# **Central Planning Authority**

**Agenda** for a meeting of the Central Planning Authority to be held on **June 8, 2022 at 10:00am in Conference Room 1038, 1st Floor, Government Administration Building, and Elgin Avenue.**

**CPA/15/22**

Figure 6. A comparison of the previously approved development (top) and the revised proposed development (bottom) showing the increased setback from the critical sea turtle nesting beach.

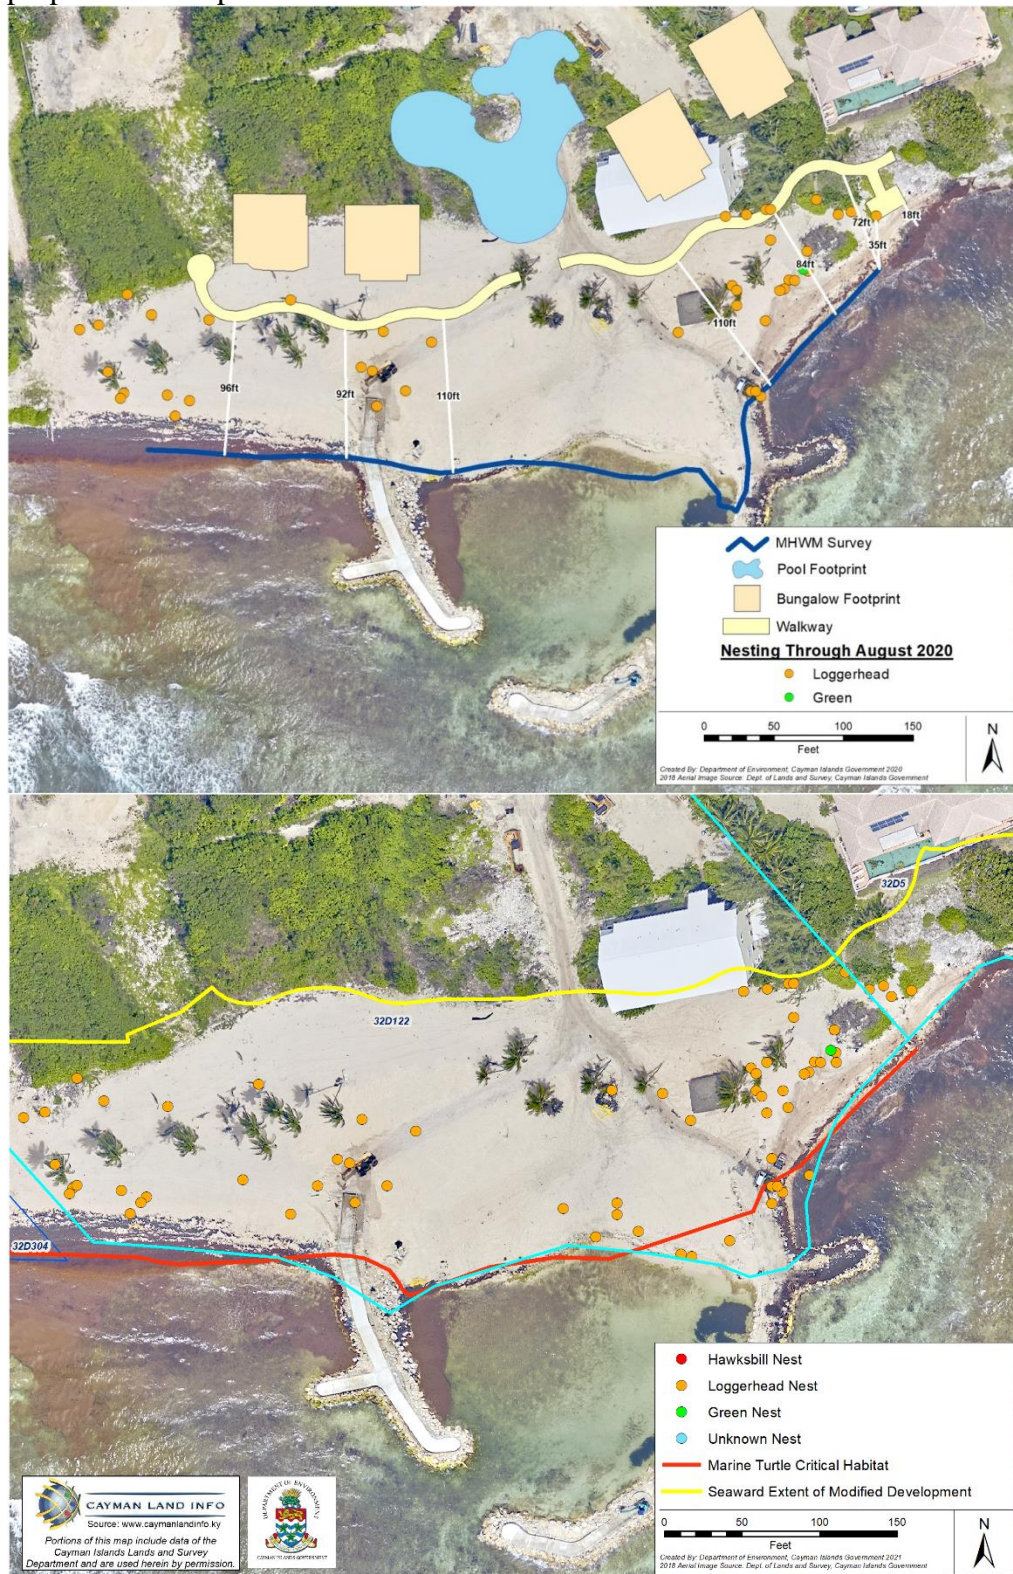
While the modifications to the proposed development have not removed all of the impacts, the modifications to remove the beachfront villas are a significant improvement. The approved development included beachfront villas, a pool deck, a guest services area, a pathway and a sewer directly on the beach, which had the effect of reducing the beach area by almost half in some areas.

Parts of the boardwalk were located a mere 18-35 feet from the high water mark in a key area of turtle nesting. Figure 6 below compares the previously approved development and the revised proposed development.

Figure 7. The revised proposed development is located narrowly off the beach.

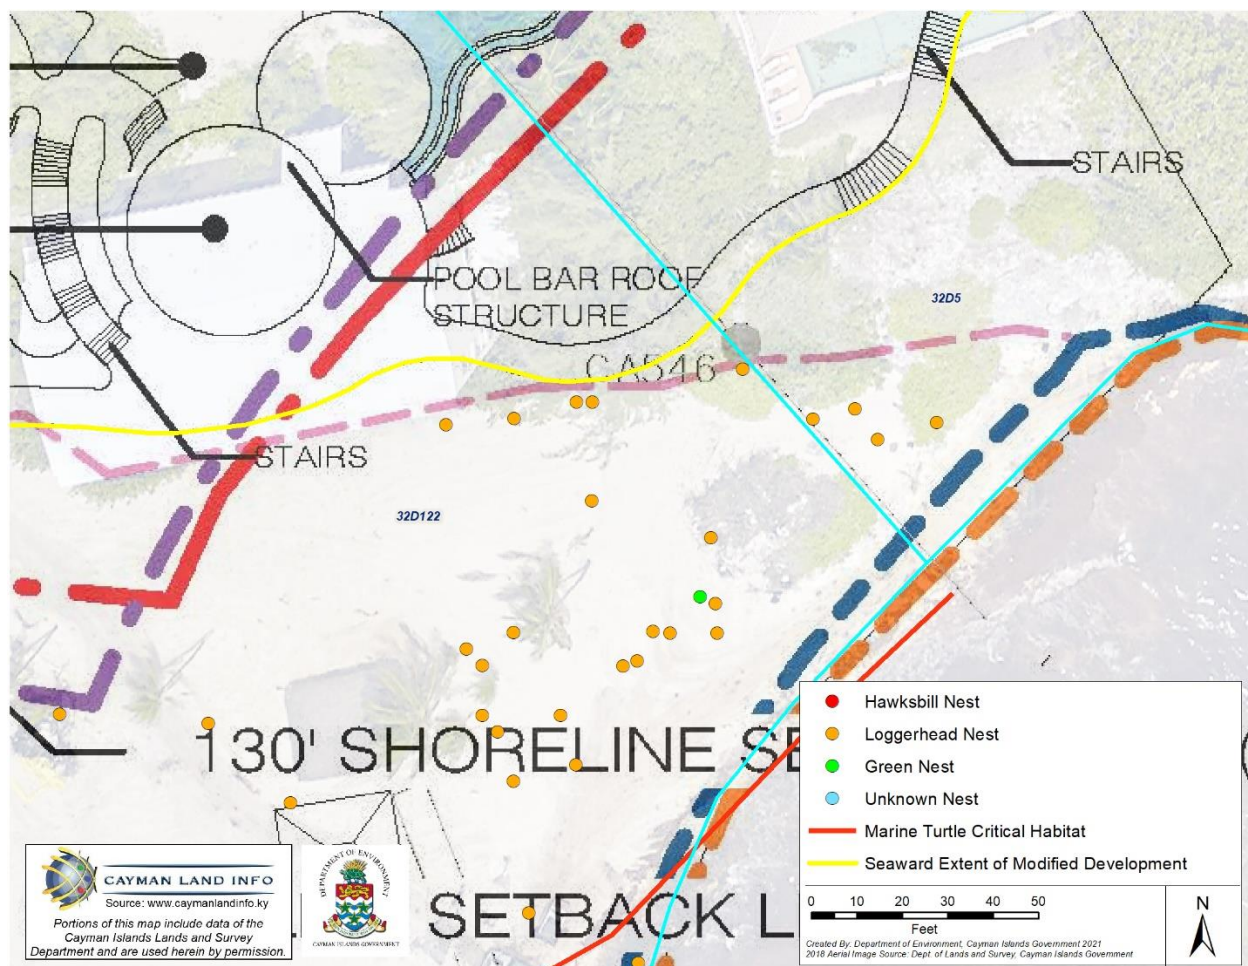
Of particular concern with the previous iteration of the Proposed Development was the eastern side of Beach Bay where the setback was the smallest. The revised proposed development has moved the paths narrowly off of the beach and off of the direct critical habitat (Figure 7).

There are still likely to be indirect impacts during operation, as well as potential direct and indirect impacts on sea turtles during construction. As this beach is now designated **sea turtle critical habitat**, we have directed conditions to prevent the ‘take’ of sea turtles.

*Figure 2: A plan extract showing the unpermitted seawall, highlighted in yellow, on the submitted proposal plans (Dart, 2022).*

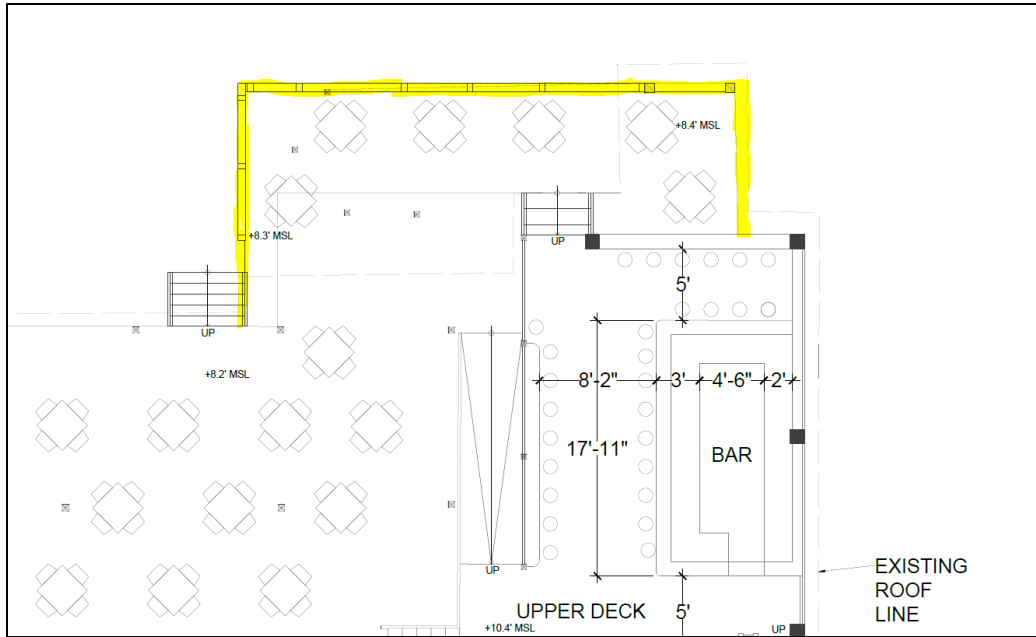
It is well-documented that hard structures, particularly those such as seawalls, that are built on a section of beach where waves can impact them cause the reflection of wave energy and the erosion of sand from the coastline seaward of them. Seawalls on beach coastlines should be located as far landward and as close to the structure they are protecting as possible to reduce the risk of direct wave impact and reflection. It is important to also highlight that setbacks seek to provide protection to properties against these inevitable effects of climate change such as coastal flooding and erosion by ensuring that hard structures are not located in an area susceptible to these hazards. The size of the parcel is sufficient to allow for the development to be located much further inland and in a way that would allow the coastal setbacks to be met.
